State of California
AIR RESOURCES BOARD

**SPECIFICATIONS FOR FILL PIPES AND OPENINGS OF
2015 AND SUBSEQUENT MODEL MOTOR VEHICLE FUEL TANKS**

Adopted: March 22, 2012
Amended: May 31, 2019

Note: The proposed amendments to this document are shown in underline to indicate additions and ~~strikeout~~ to indicate deletions compared to the test procedures as adopted March 22, 2012. [No change] indicates proposed federal provisions that are also proposed for incorporation herein without change. Existing intervening text that is not amended in this rulemaking is indicated by “* * * *”.

Figure A: Alternate Shape 2, cross-section of a vehicle fill pipe head.

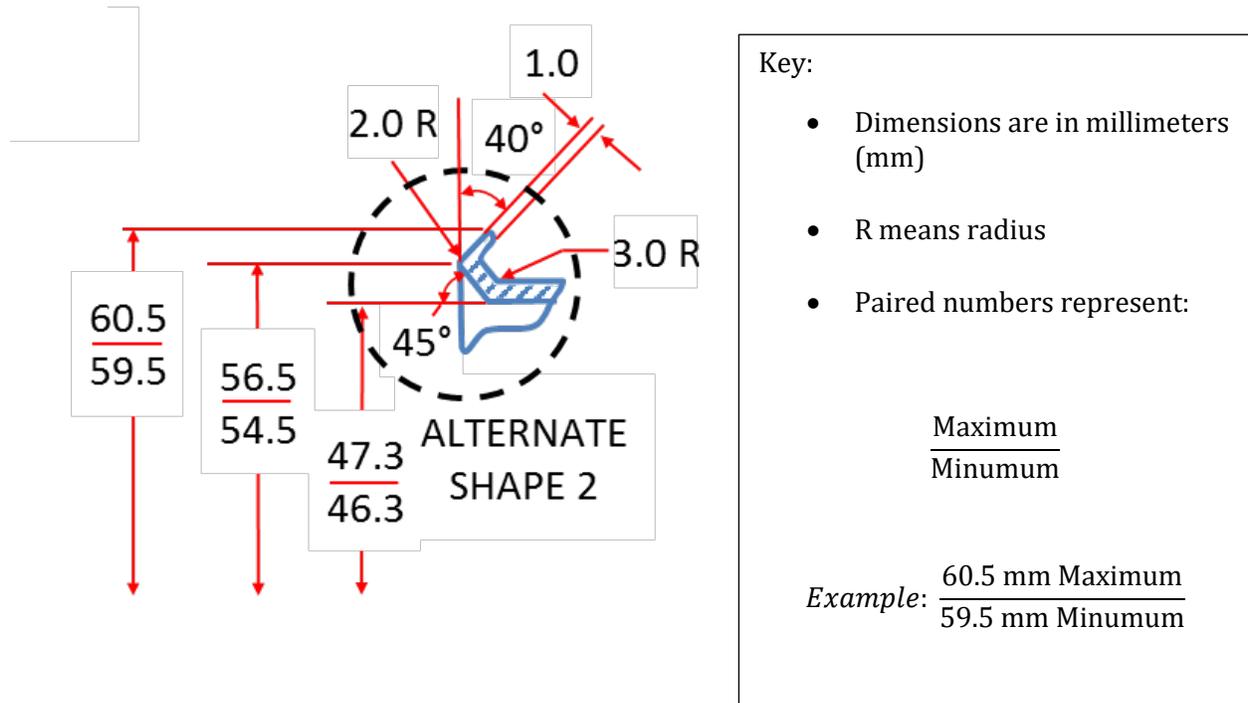
- A. Fill pipe sealing surface, modifying or adding to ISO 13331-1995(E) Section 3.1 as adopted June 1, 1995:
- “Fill pipe sealing surface” means portion of the fill pipe face which would contact the vapor recovery nozzle boot face.
 - Diameter of the sealing surface of the fill pipe shall have a maximum diameter of 57.9 mm.
 - Fill pipe surfaces outside of the 57.9 mm diameter of the sealing surface are allowable so long as it does not infringe into the 40 degree tapered access zone, which extends to a depth of 12 mm back from the sealing surface of the fill pipe as described in Figure B.
 - These added provisions apply only when a manufacturer is changing the design of their vehicle’s fill pipe head for model year 2024 and subsequent vehicle fleets.

Figure B: Additional access zone, showing how the zone shape changes when applied to fill pipes with different sealing surface diameters.

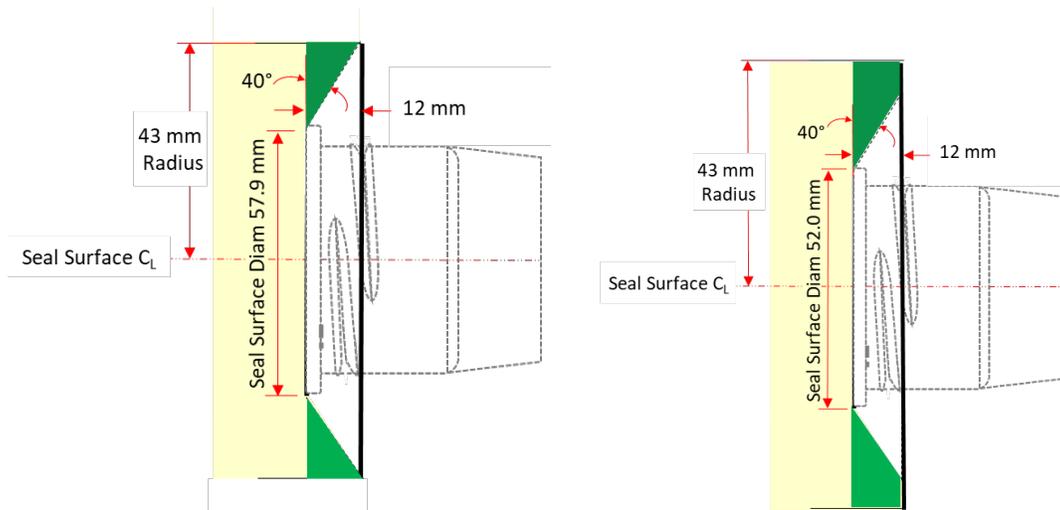
- C. Modification to access zone, modifying ISO-13331-1995(E) Section 3.3:
- a. The fill pipe and any other vehicle parts shall not occupy space defined by the additional access zone shown in Figure B in green. The additional access zone is centered on the axis of the fill pipe sealing surface's outer diameter, and applies around the entire perimeter of the fill pipe. The additional access zone shall line up flush with the seal surface as shown in Figure B. The yellow shaded area represents the shape of a nozzle boot and is shown for reference only.

- b. This modification replaces the 2.5 mm dimension of the portion of the access zone described in Figure 5, view X of ISO-13331-1995(E).
 - c. This modification applies only when a manufacturer is changing the design of their vehicle's fill pipe head for model year 2024 and subsequent vehicle fleets.

Figure C: Set-up of Testing Equipment

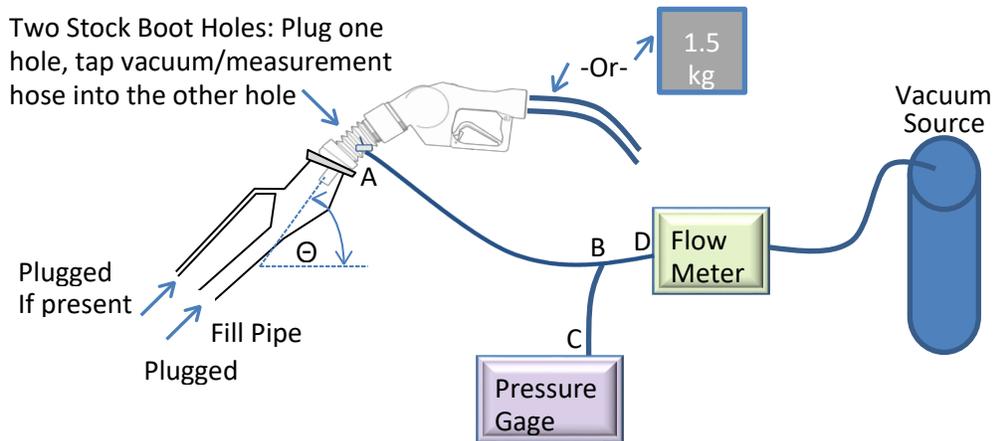
- A. Secure the test fill pipe into the fill pipe mounting fixture.
 - a. Fill pipe should be oriented such that:
 - i. Fill pipe opening, at center, is at a height of 37 +/- 2 inches above the ground.
 - ii. Pipe axis angle with respect to horizontal shall be 32 +/- 2 degrees.
 - iii. Internal locking lip degrees on each side of the vertical reference plane meet the vehicle manufacturer's specification, within +/- 5 degrees.
- B. Interconnect the fill pipe, flow meter, pressure gage, and vacuum source, as shown in Figure C.
 - a. Vacuum and pressure/flow measurement hose shall be routed inside the assist vapor recovery nozzle's (assist nozzle¹) boot.

- C. The outlet of the fill pipe shall be plugged.
- D. If the fill pipe has a recirculation line, the recirculation line shall be plugged.
- E. One of the two pre-existing holes in the boot of the assist nozzle shall be used for routing the hose that connects the vacuum source, pressure gage, and flow meter into the nozzle, and the other hole shall be plugged.
- F. The hose dimensions shall be as indicated in Table 1.
